## TOYOTA TACOMA

### OUTLINE OF NEW FEATURES

The TOYOTA TACOMA is a high-performance pick up with sporty and powerful style. The following changes are made for 2000 model year.

##### Cylinder Head

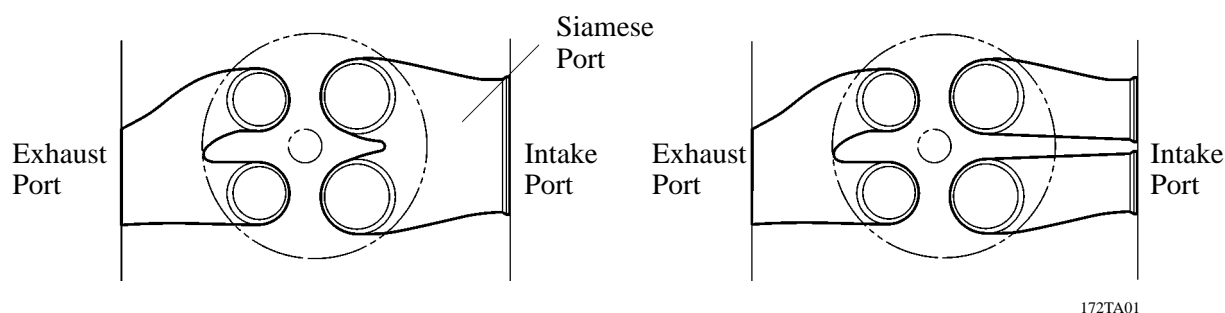
A Siamese port configuration has been adopted for the intake port of the cylinder head.

**Valve Mechanism**

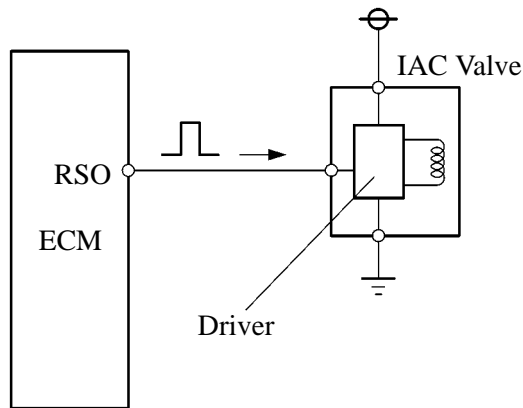
The valve timing has been changed.

Model		California Specification Model	Except California Specification Model
Intake	Open	2° BTDC	5° BTDC
	Close	48° ABDC	45° ABDC
Exhaust	Open	42° BBDC	←
	Close	2° ATDC	←

**1) IAC Valve**

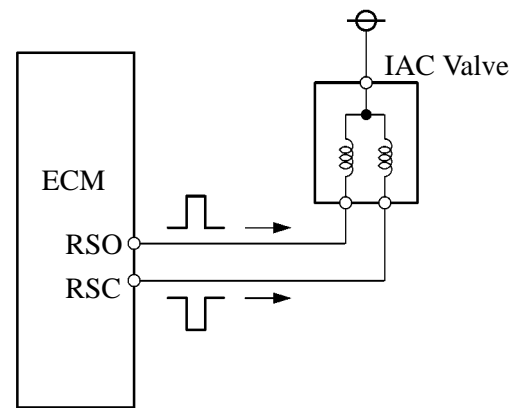
A compact, 1-coil type IAC valve has been adopted.

**2) Intake Manifold**

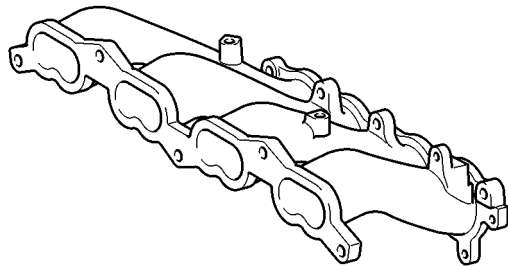
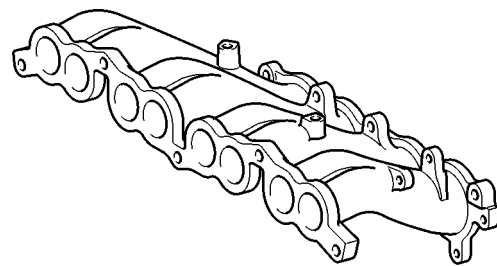
Along with the change in the shape of the intake port of the cylinder head, the intake manifold has been changed.

### 3) Exhaust Manifold

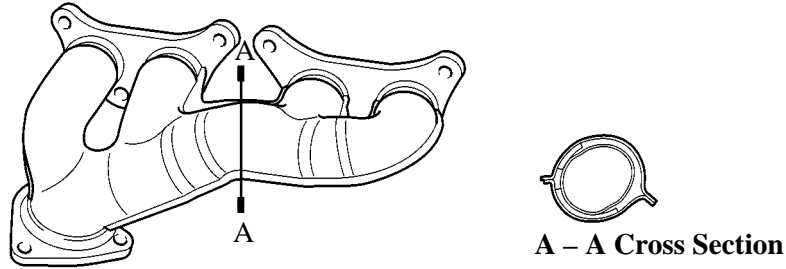
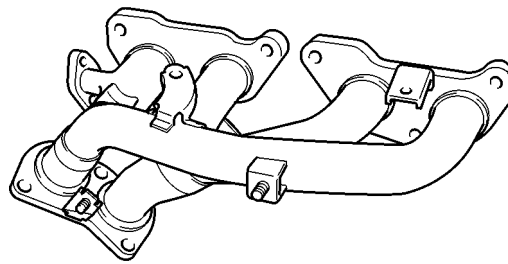
An exhaust manifold made of stainless steel has been adopted.

A manifold with double-wall construction has been adopted on the 2RZ-FE engine.

### 4) Exhaust Pipe

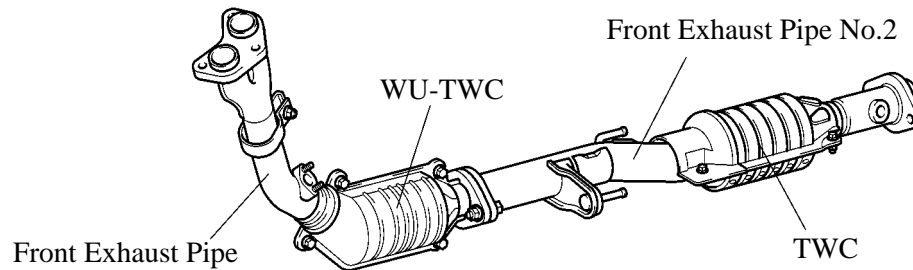
A WU-TWC (Warm-Up Three-Way Catalytic Converter) has been adopted on the front exhaust pipe, and a TWC (Three-Way Catalytic Converter) has been adopted on the front exhaust pipe No.2.

**Ignition System**

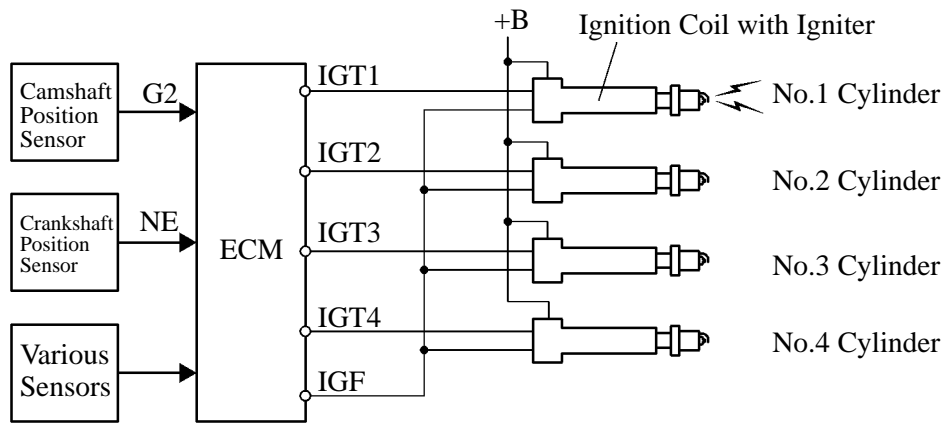
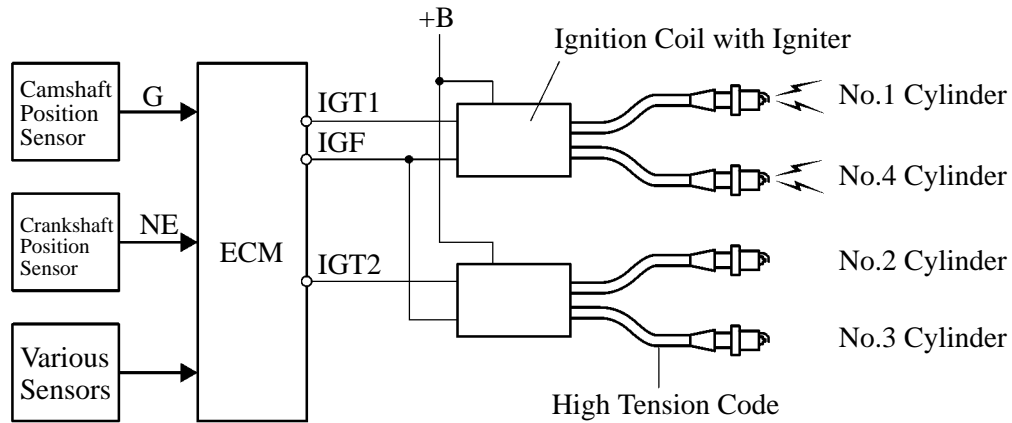
The DIS (Direct Ignition System) in the California specification model is an independent ignition system which has one ignition coil for each cylinder.

This system consists of an igniter, ignition coil, and plug cap as a single unit, thus eliminating the high tension cord.
